City of Columbia

Municipal Planning Commission

September 8, 2021

AGENDA.....	1
MINUTES.....	2
LETTERS OF CREDIT.....	3
 <u>CASE 21-0138</u> Request from Crunk Engineering for preliminary plat approval of Jim Baker Subdivision off Morrow Lane.....	4
Staff Report Attachments	
 <u>CASE 21-0145</u> Request from Martin Engineering to annex with a plan of services and master plan for property off Bear Creek Pike being a portion of Tax Map 90 Parcels 12 and 13.00 and rezone the remaining portion with a base zoning of High Density Residential Planned Unit Development.....	5
Staff Report Attachments	
 <u>CASE 21-0160</u> Request from Chapdelaine and Associates to rezone properties off East 7th Street being Tax Map 99A Group G Parcels 5,6,7, and 8.00 from MCD to R-6.....	6
Staff Report Attachments	
 <u>CASE 21-0161</u> Request from Scott Bernick to rezone 431 Cord Drive being Tax Map 113E Group B Parcel 12.00 from GCS to RM-2.....	7
Staff Report Attachments	
 <u>CASE 21-0162</u> Request from T-Square Engineering to annex with a plan of services a portion of Tax Map 52 Parcel 14.00 off Frye Road with a zoning of R-6.....	8

C1.0

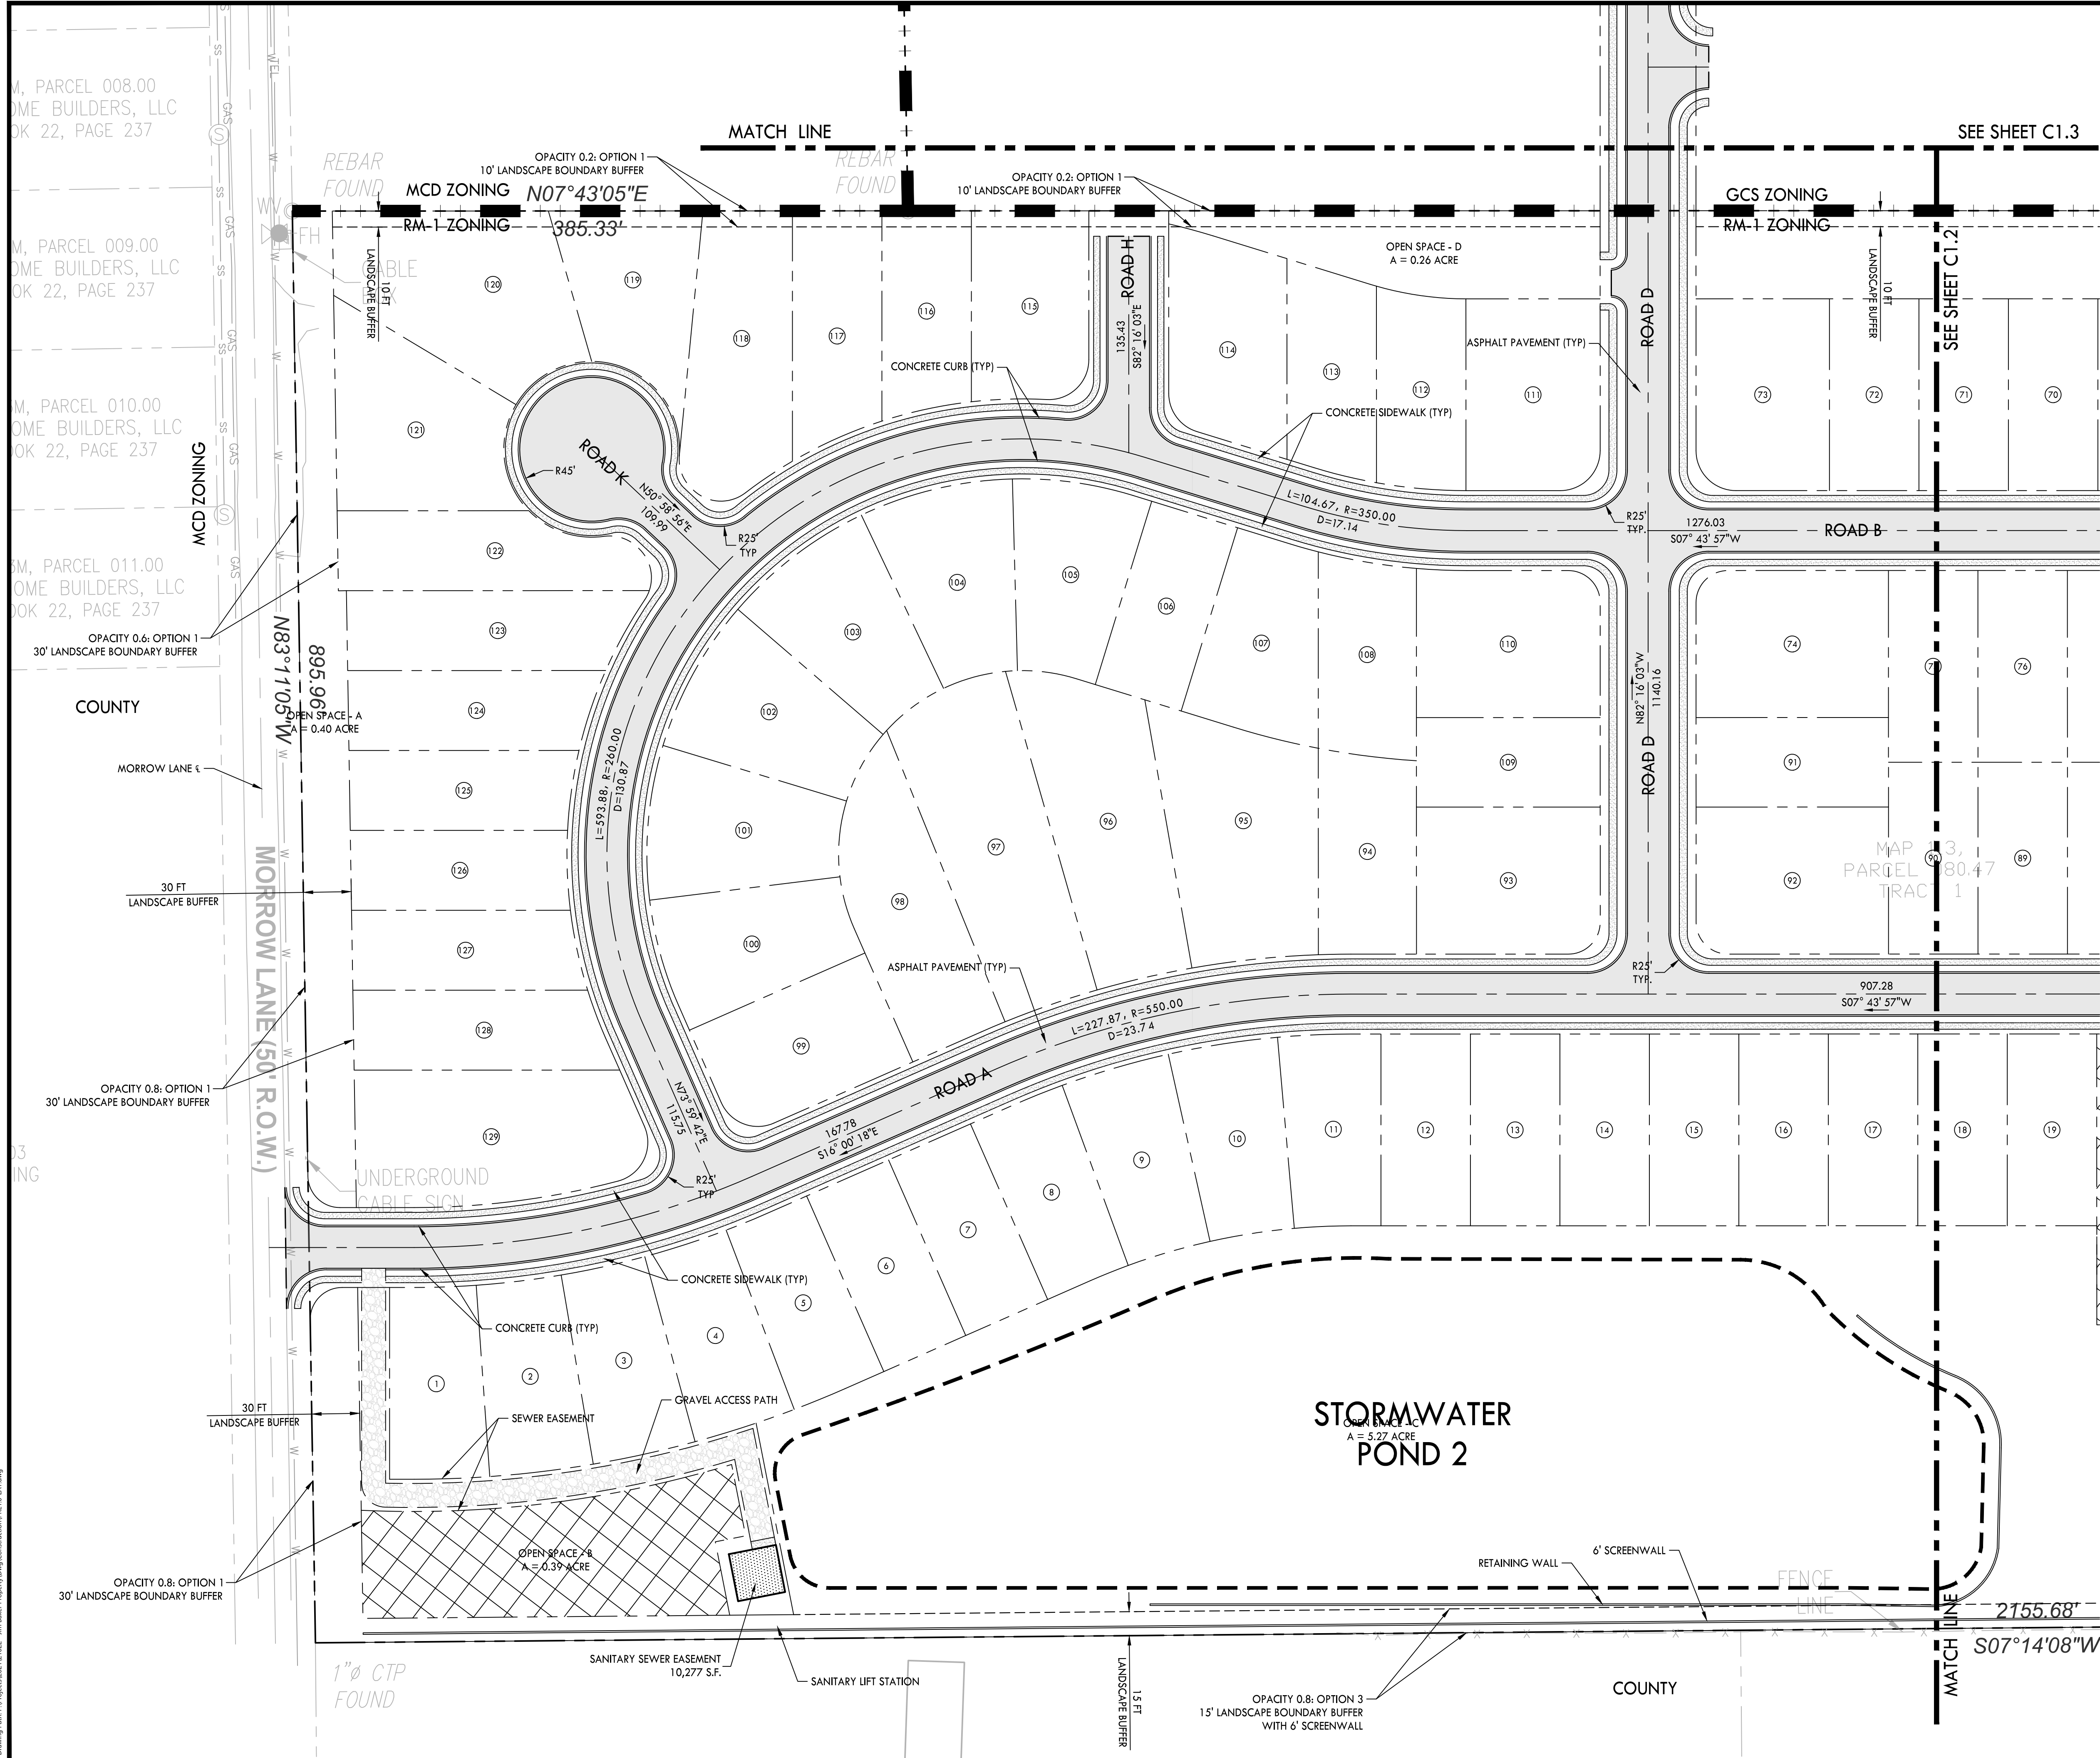
1. Preliminary plat will need to confirm adequate sight distance at both access points to public ROW
2. Subject to TIS and construction plans
3. Provide an emergency spillway and drainage ditch from "stormwater pond 2" out to Morrow Lane

6. Provide road names to E911 for approval.
7. Road F should intersect Road A and Road G should intersect Road F.
8. Offsite regional detention pond serving lots on Park Plus Drive discharges towards lots 58-64 with no outlet.

12. What is lot 129 going to be used for as shown
13. show buffer areas around perimeter
14. will this be phased
15. Corner lot detail needed
16. site data table is showing another location information

PUD MASTER PLAN PEWETT PLACE COLUMBIA, TENNESSEE MAURY COUNTY AUGUST 12, 2021

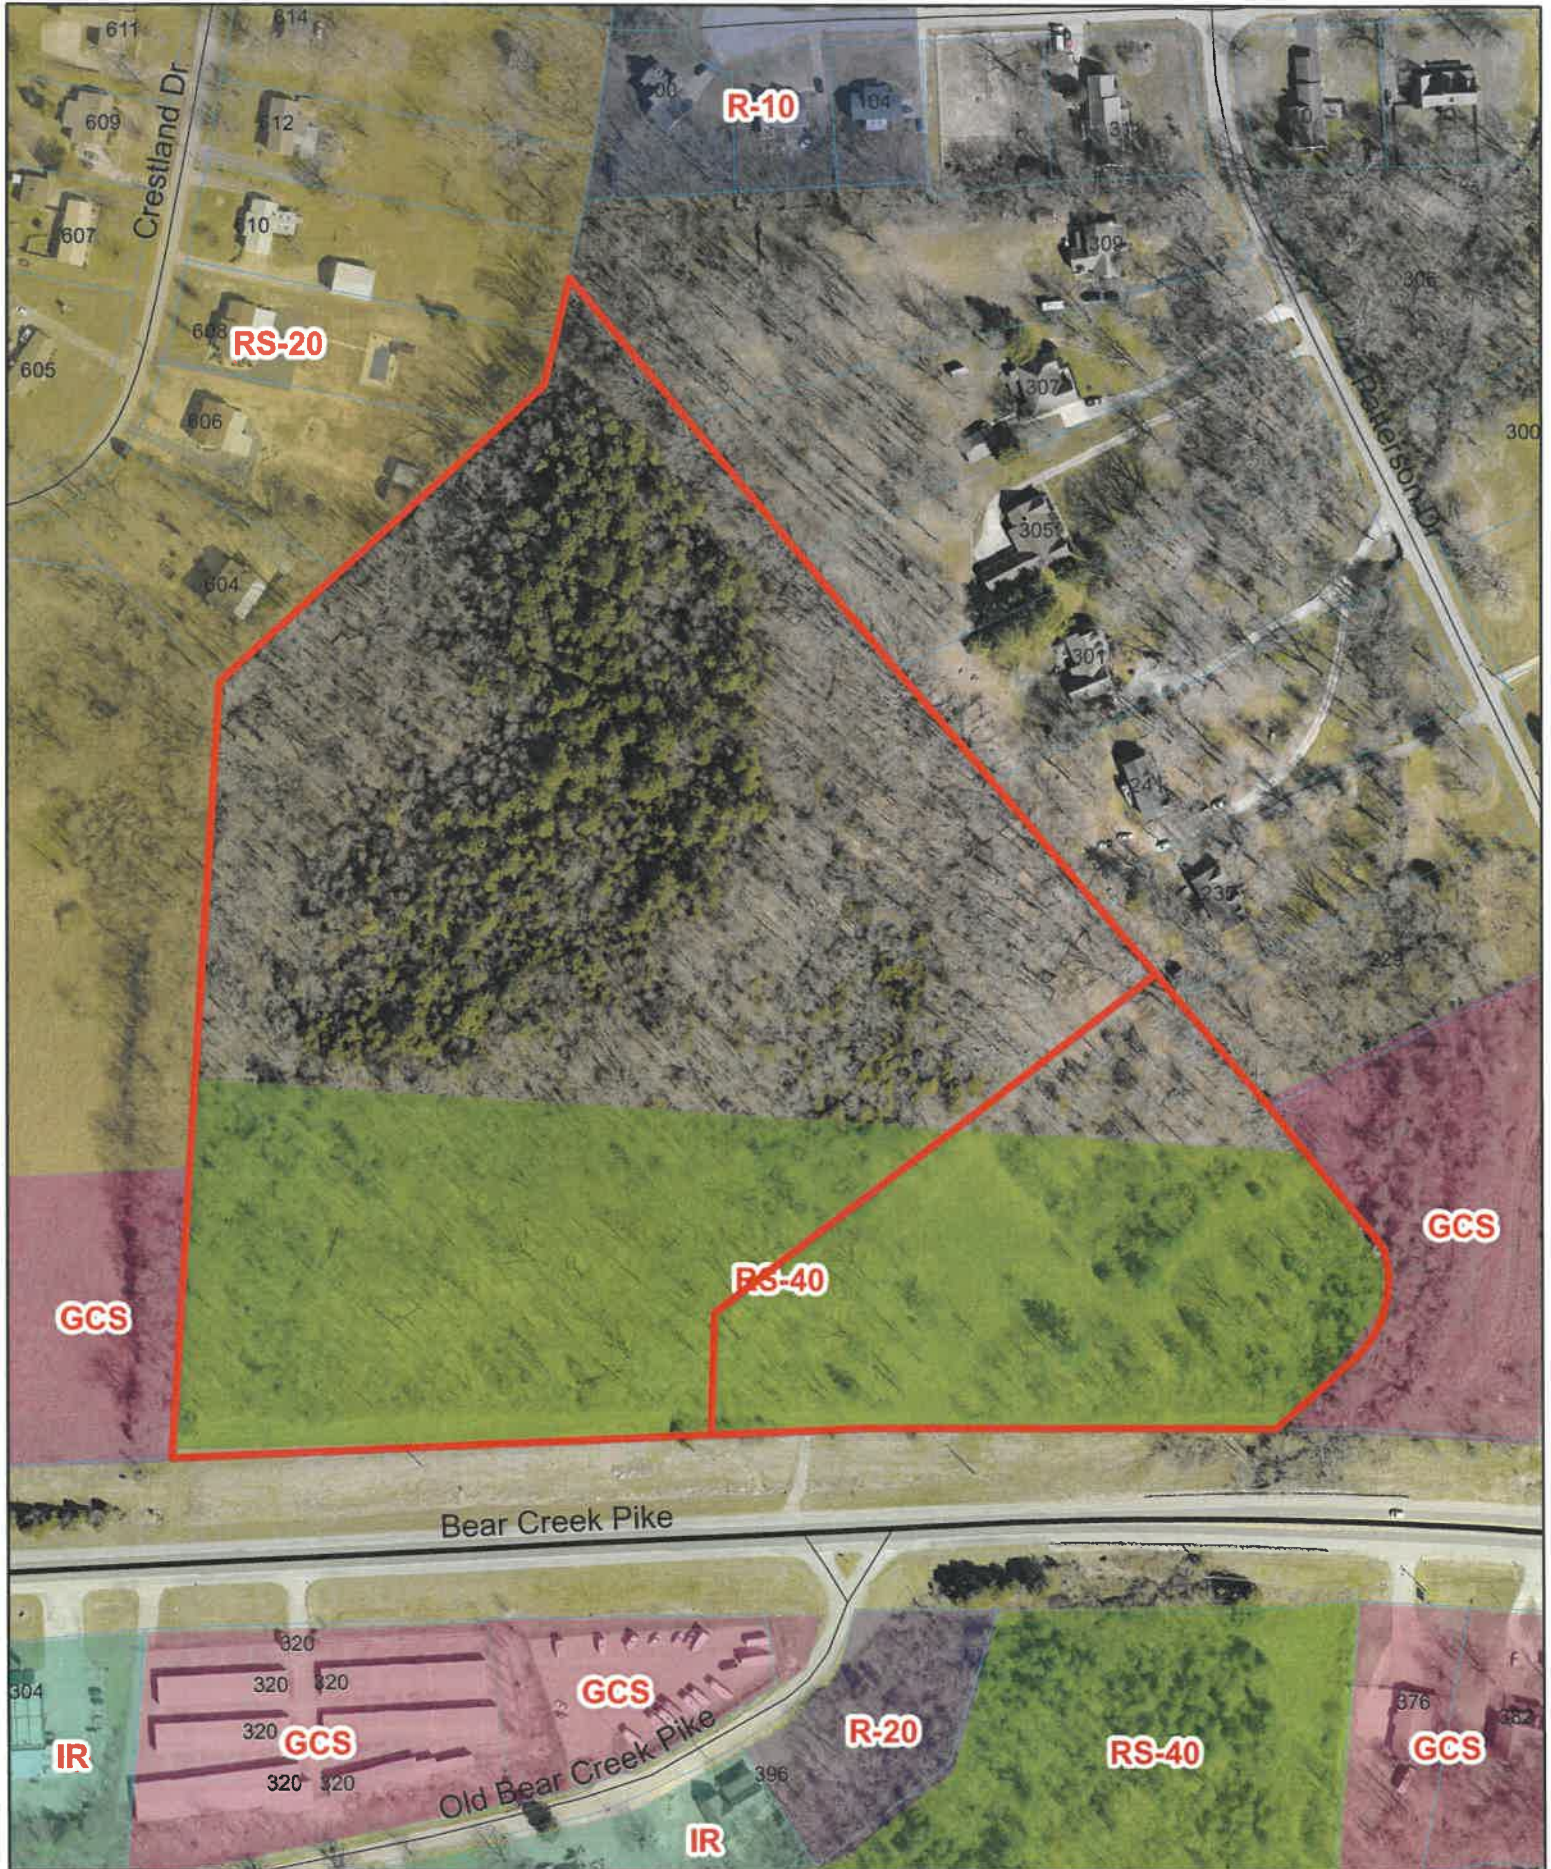
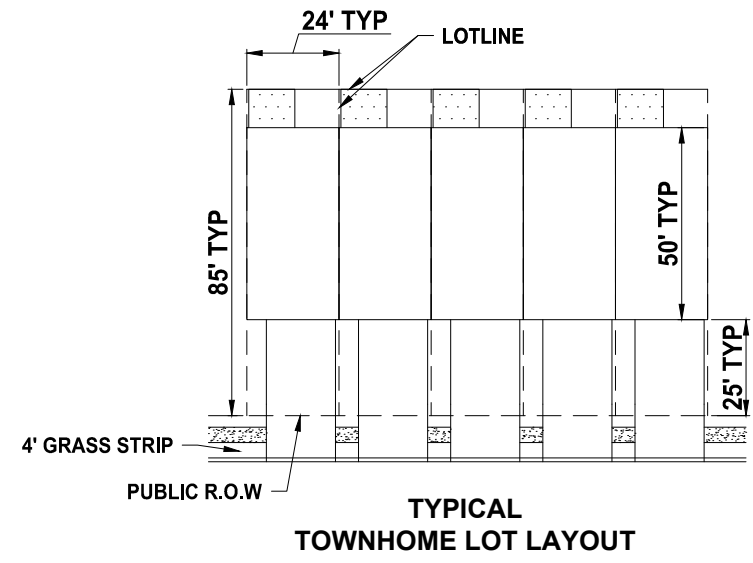
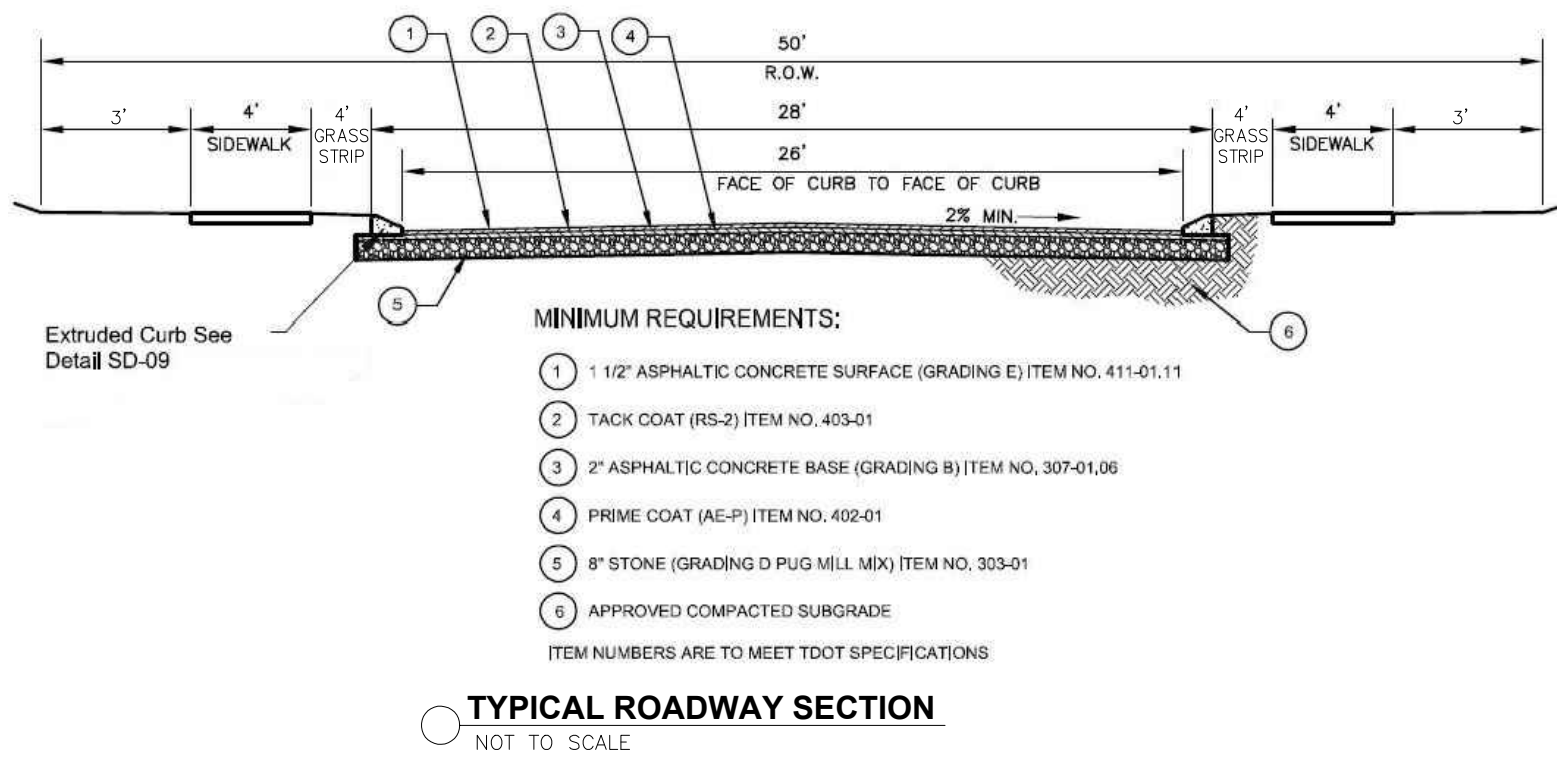
7. Provide ROW and stub road to East (Map 90 Parcel 14.06) to align more or less with the northern property line of this adjacent parcel.

9. Provide proposed grading

10. Provide cul de sacs for permanent turnaround along Mansfield Ct

11. Provide roadway cross section with R.O.W.

21. The site is mostly forest area please show any areas not disturbed that would preserve established vegetation

Response: Completed

Response: Proposed grading has been provided.

Response: Road has been extended to eliminate need for turnaround.

Response: Typical roadway cross section with 50' R.O.W. has been provided.

Response: The site has significant slope and must be mass graded. However, trees along Hwy 412 in front of townhomes are being preserved. Also, as possible, trees along the northern and western property lines are being preserved, as generally indicated on the landscape plan.
